**ADDENDUM
NO. 7**

June 9, 2022

**Greenfield Central High School Auditorium Renovation and
Addition – Bid Package No. 2
810 N. Broadway
Greenfield, IN 46140**

**MECHANICAL DUCTWORK
 PLAN - FIRST
 FLOOR - UNIT L**

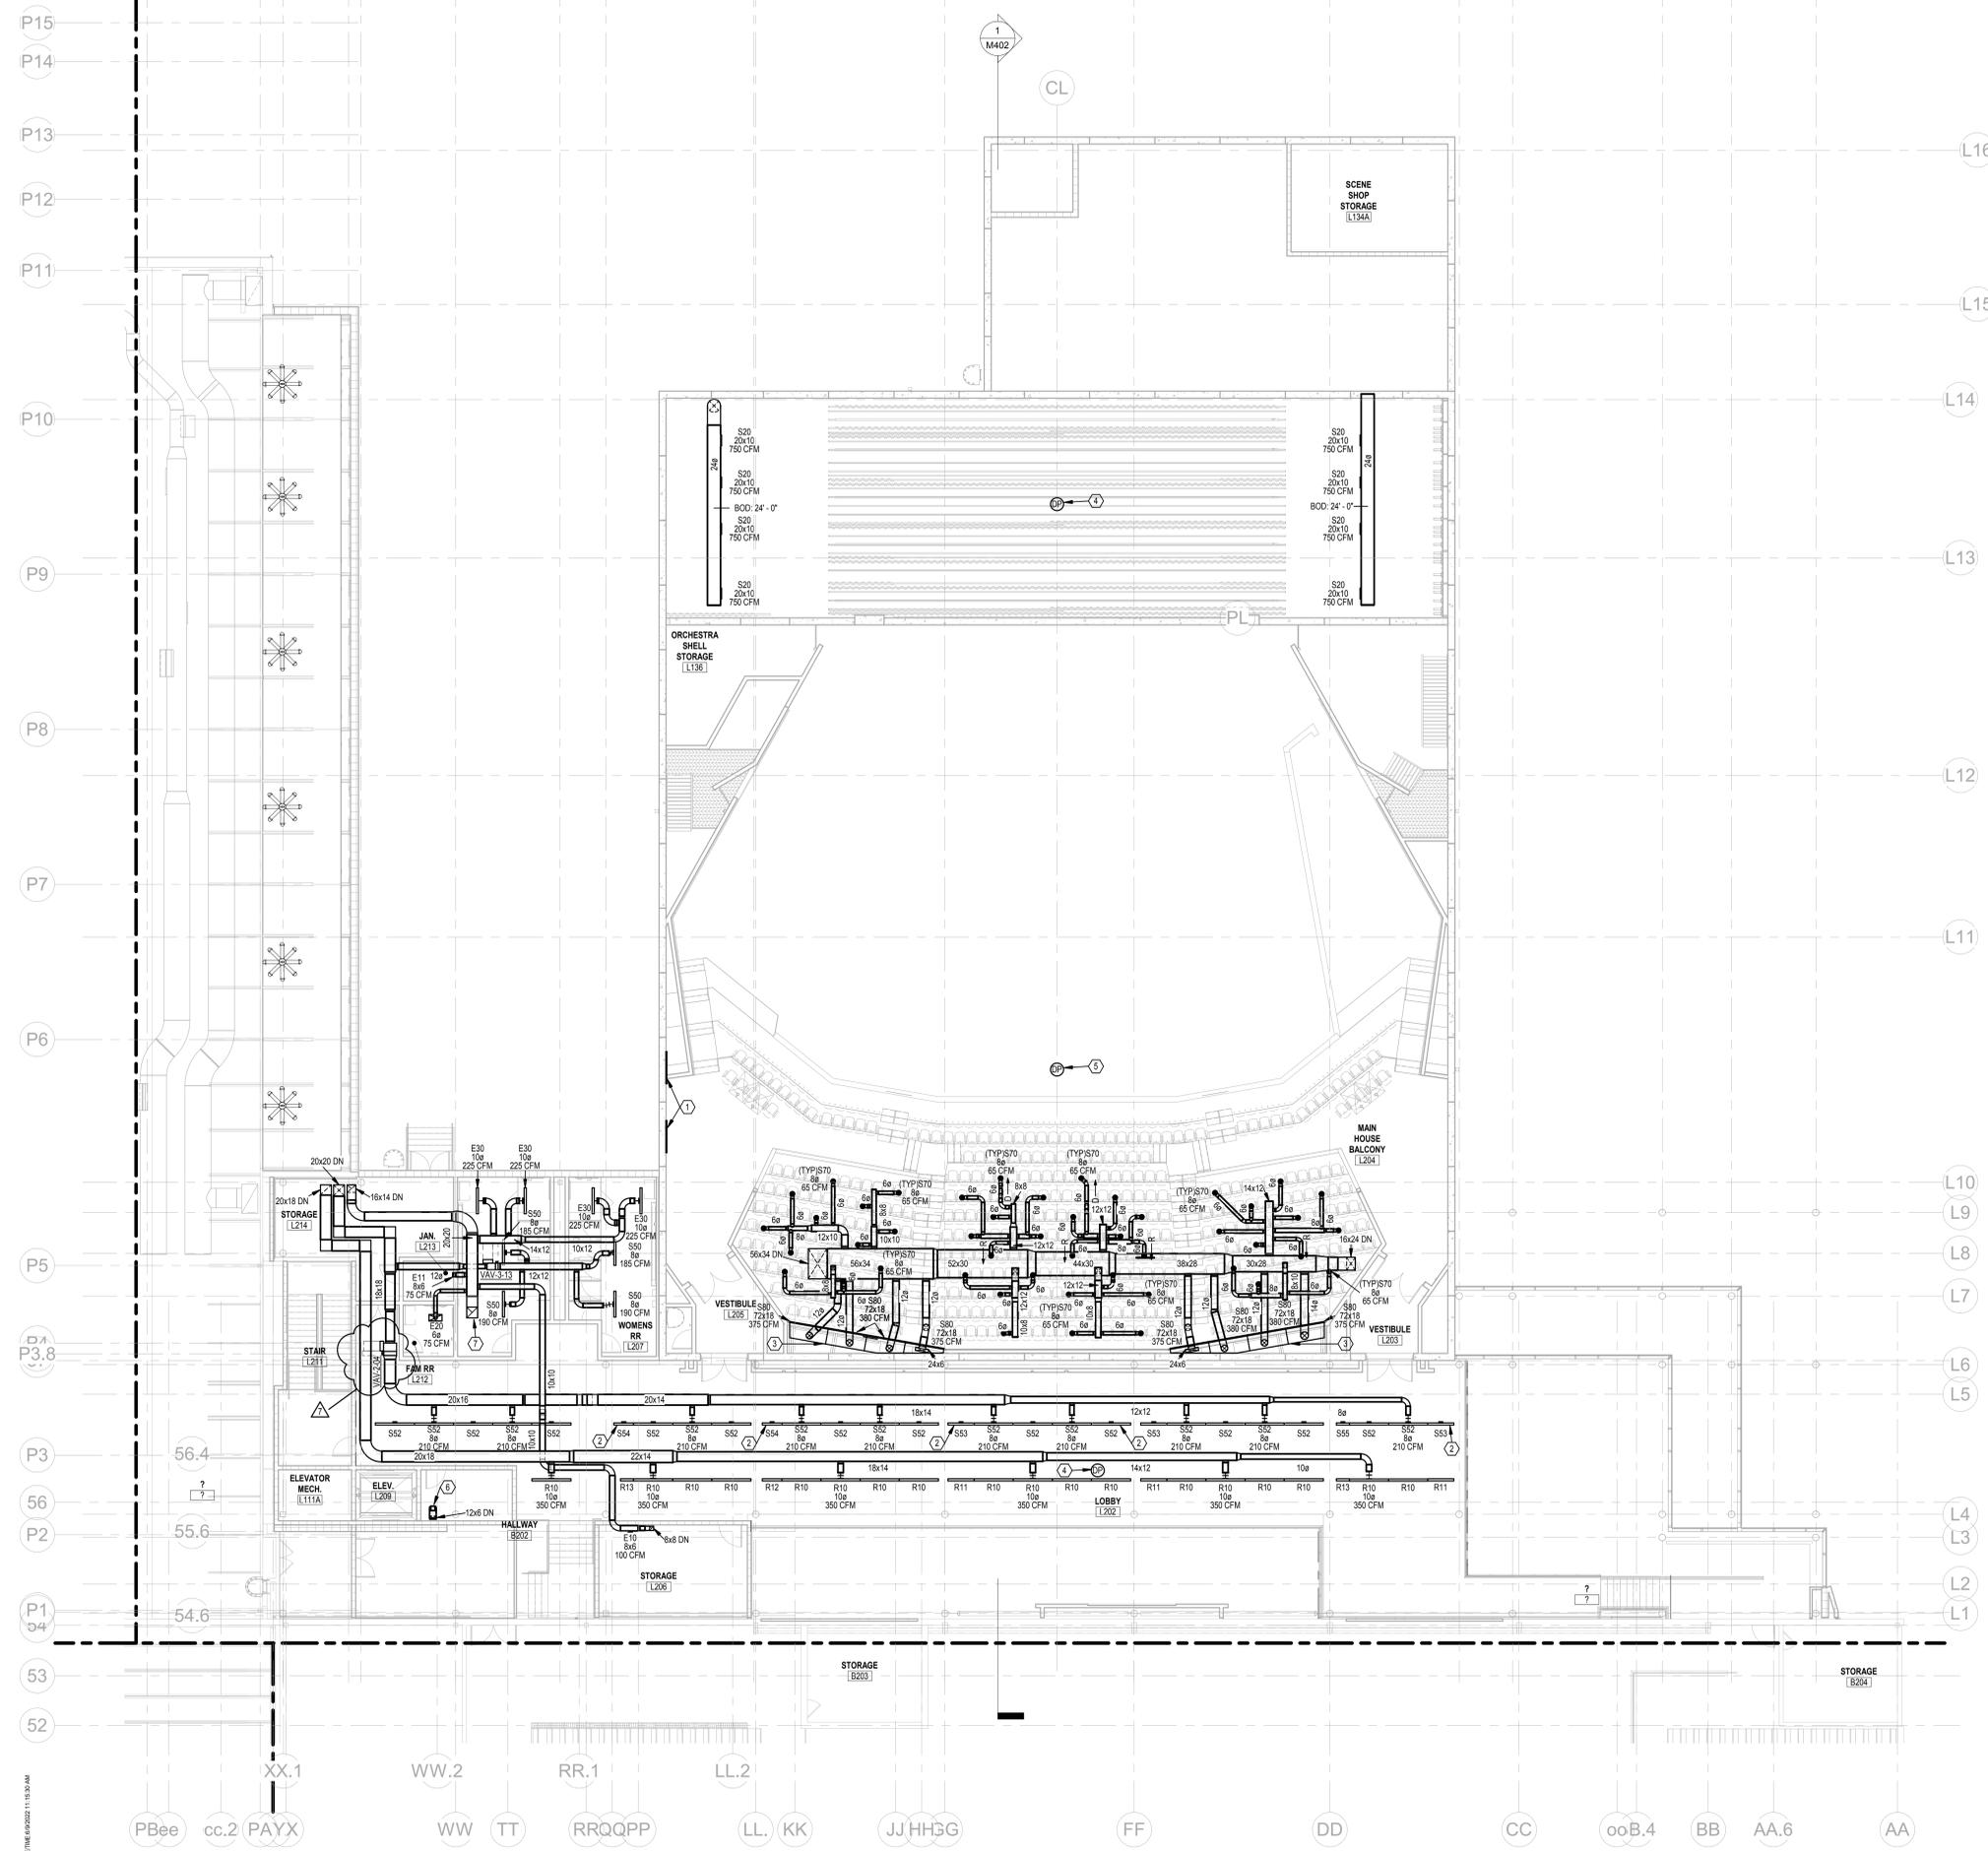
- ITEM NO. 1 M101L - MECHANICAL DUCTWORK PLAN - FIRST FLOOR - UNIT L
 - A. Add return air balancing dampers.
 - B. Modify plan note 16.
 - C. Add tags.
- ITEM NO. 2 M102L - MECHANICAL DUCTWORK PLAN - SECOND FLOOR - UNIT L

**MECHANICAL
 DUCTWORK
 PLAN - SECOND
 FLOOR - UNIT L**

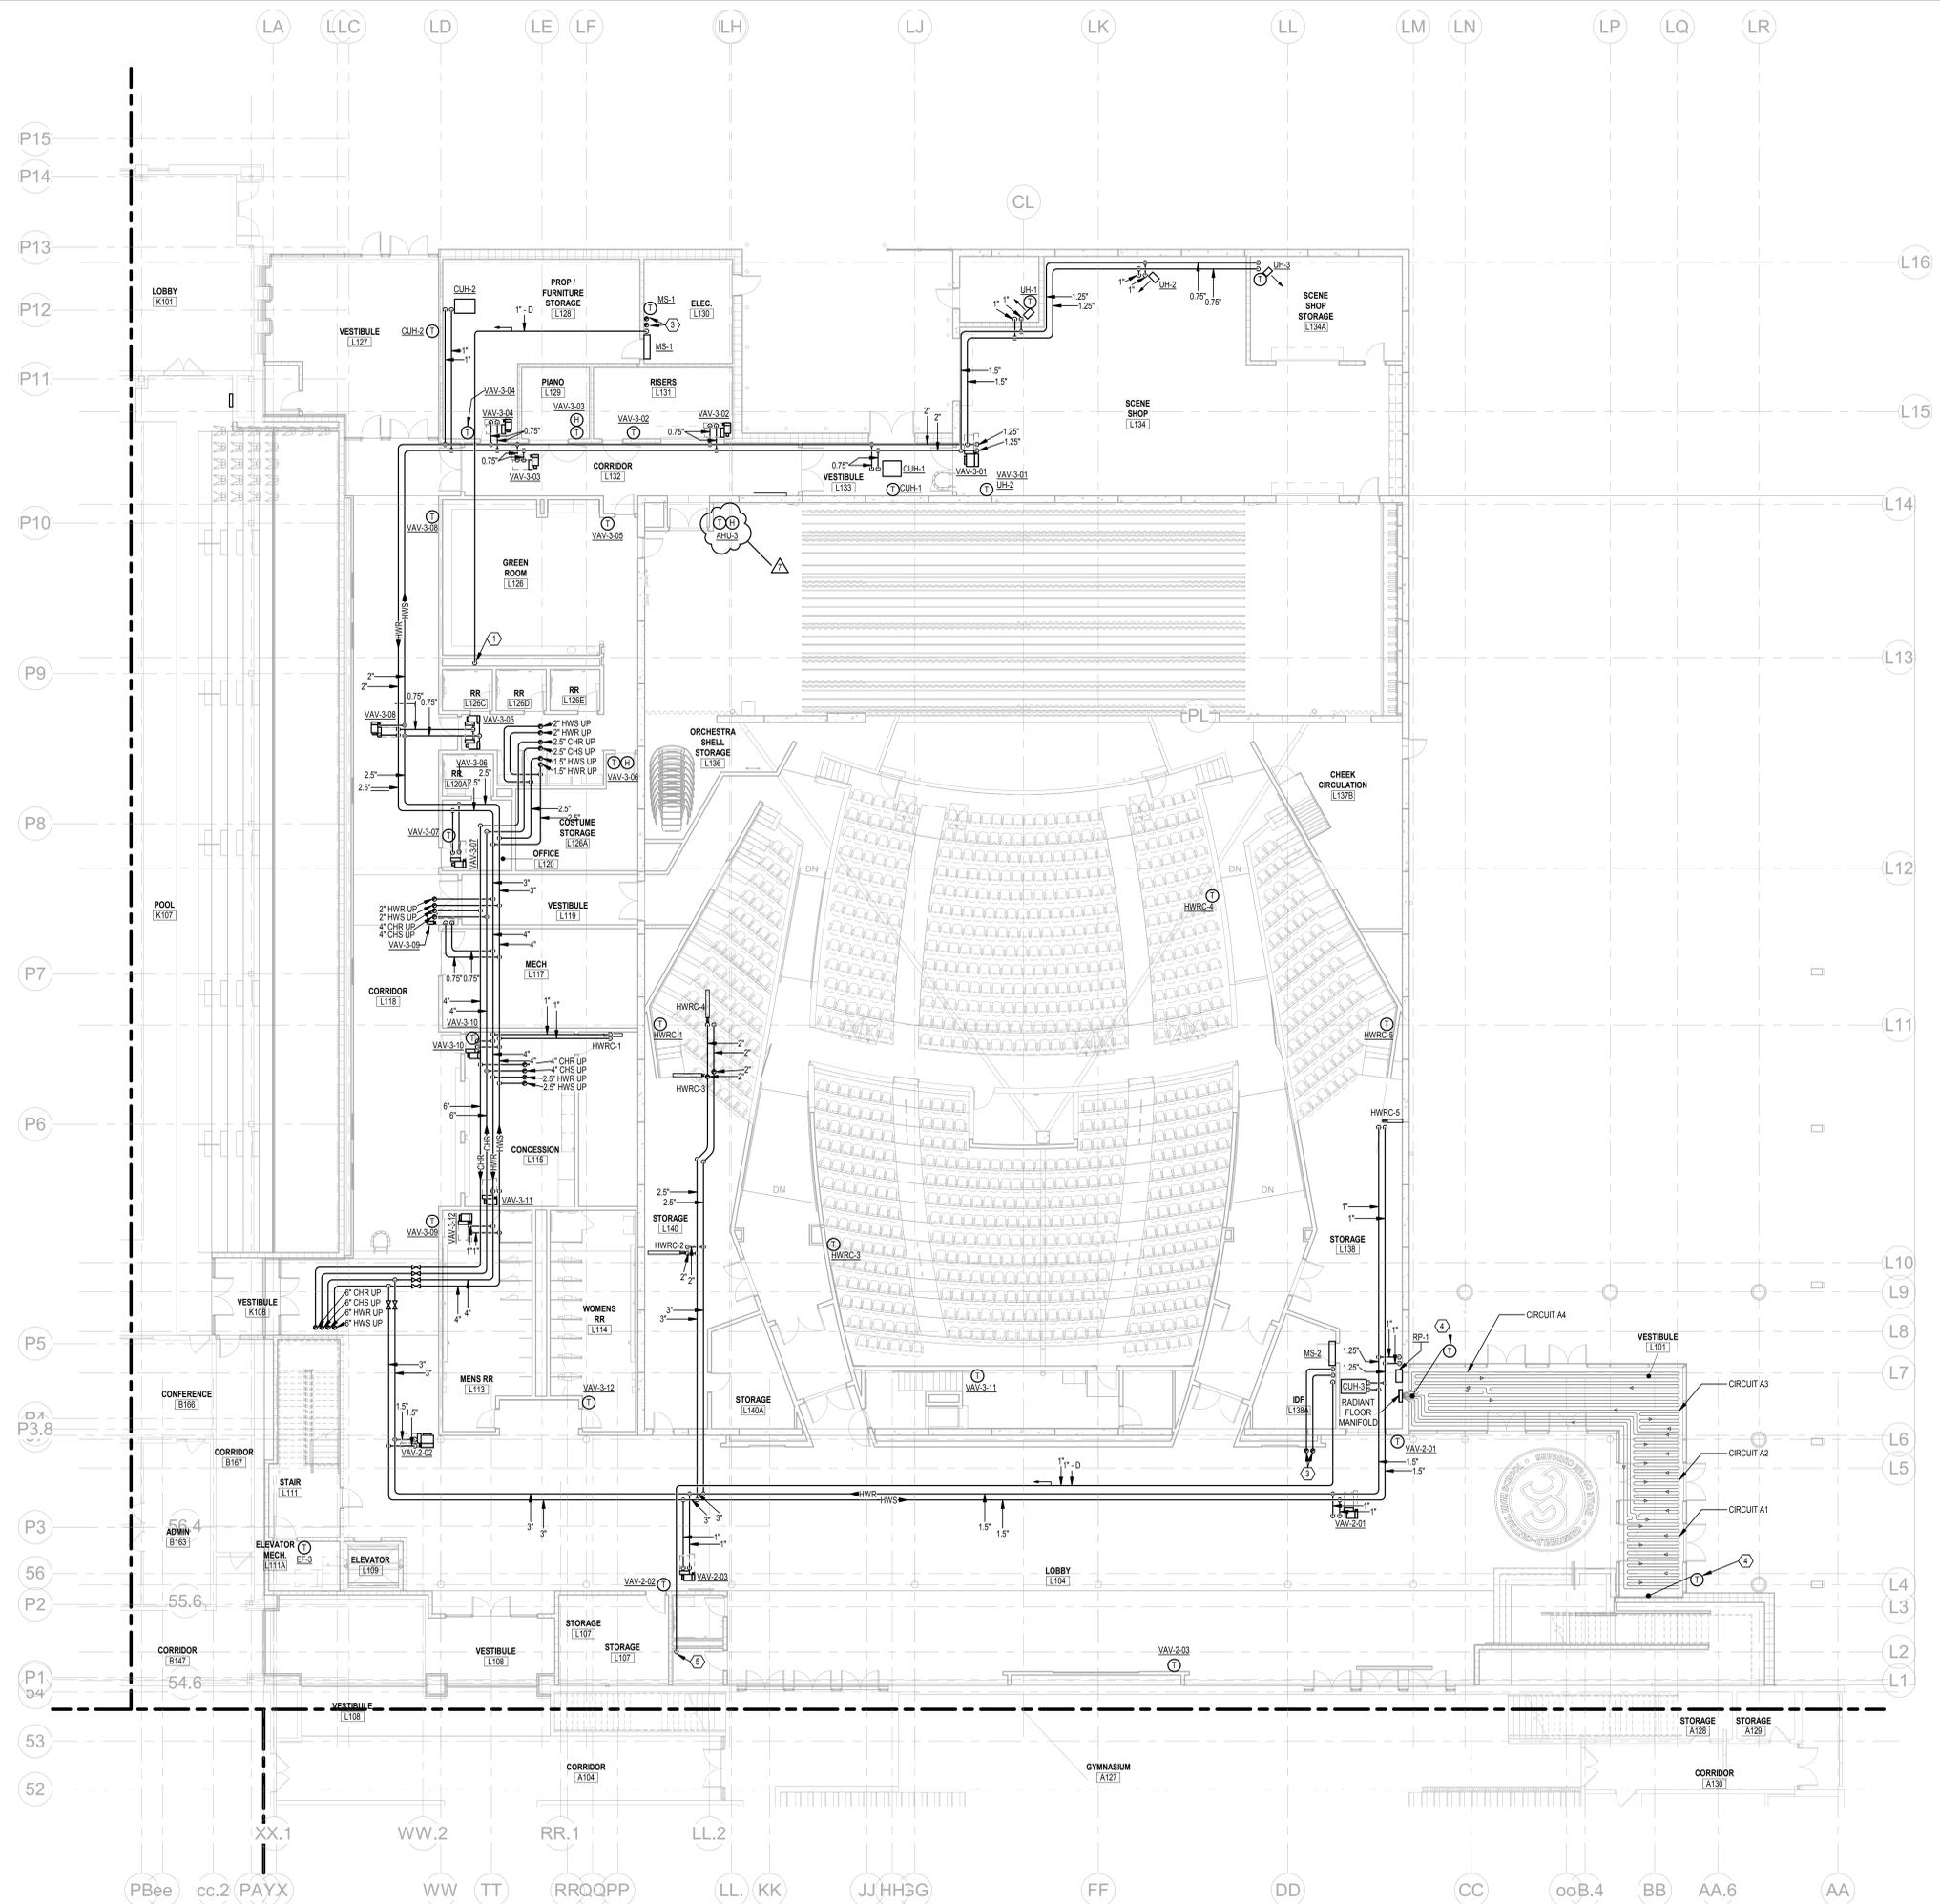
- A. Modify plan note 1.
 - B. Add tags.
- ITEM NO. 3 M201L - MECHANICAL PIPING PLAN - FIRST FLOOR - UNIT L
 - A. Modify tag.
- ITEM NO. 4 M301L - MECHANICAL ROOF PLAN - UNIT L

**MECHANICAL
ROOF PLAN -
UNIT L**

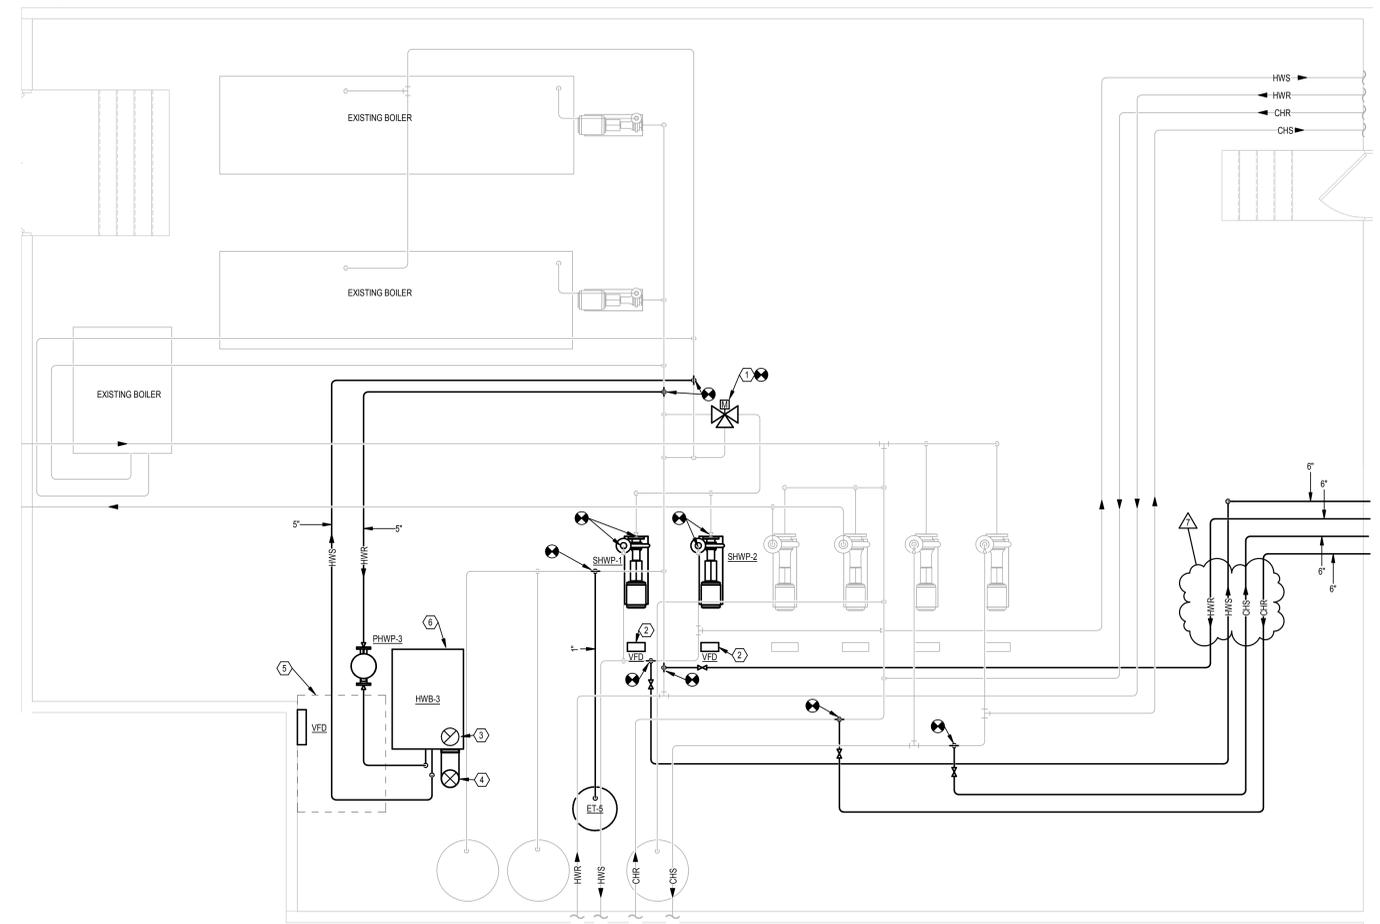
- A. Modify plan note 3.
- ITEM NO. 5 M401 - ENLARGED MECHANICAL PLANS
 - A. Modify flow arrows.
- ITEM NO. 6 M501 - MECHANICAL DETAILS
 - A. Edit details 8, 9, 11, and 13.

**MECHANICAL
DETAILS**

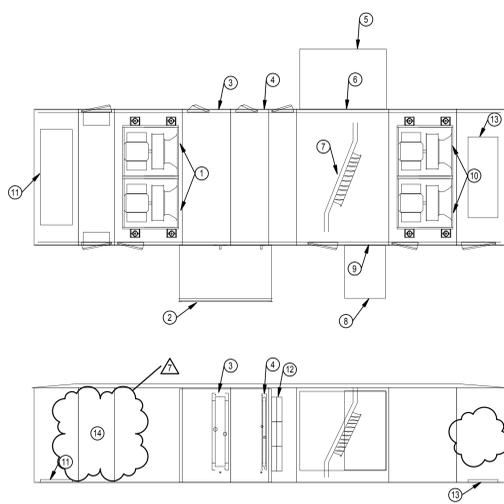
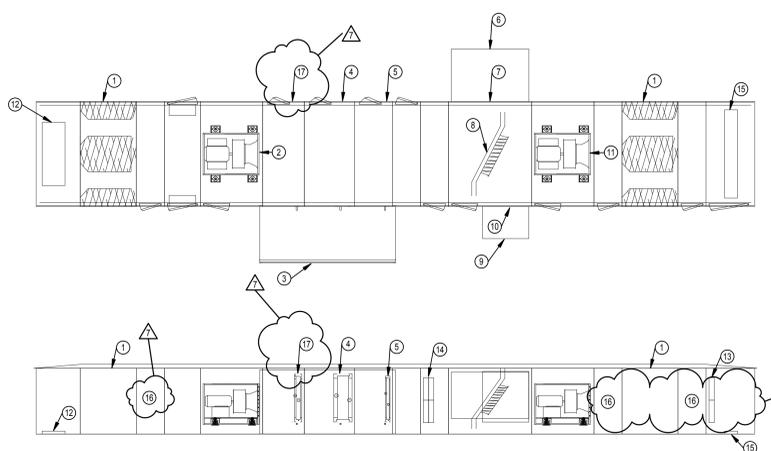
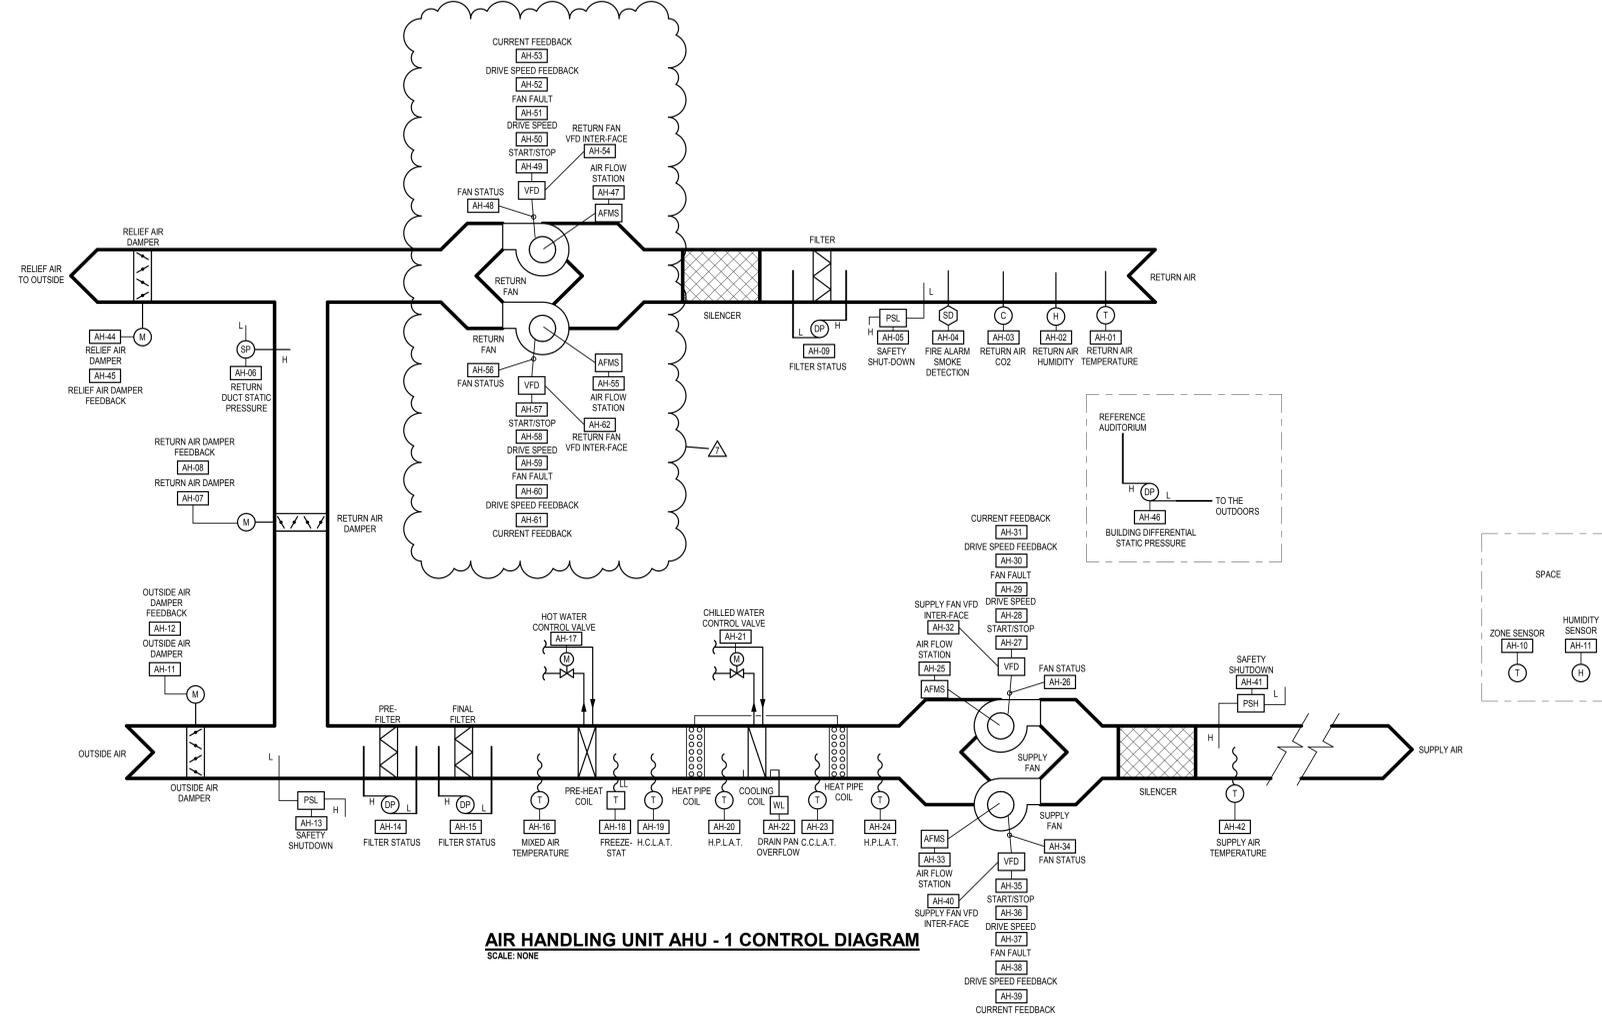
- ITEM NO. 7 M502 - MECHANICAL DETAILS
 - A. Edit details 2, 3, 6, and.
 - B. Add details 12 and 13.
- ITEM NO. 8 M503 - MECHANICAL DETAILS
 - A. Modify AHU elevations.
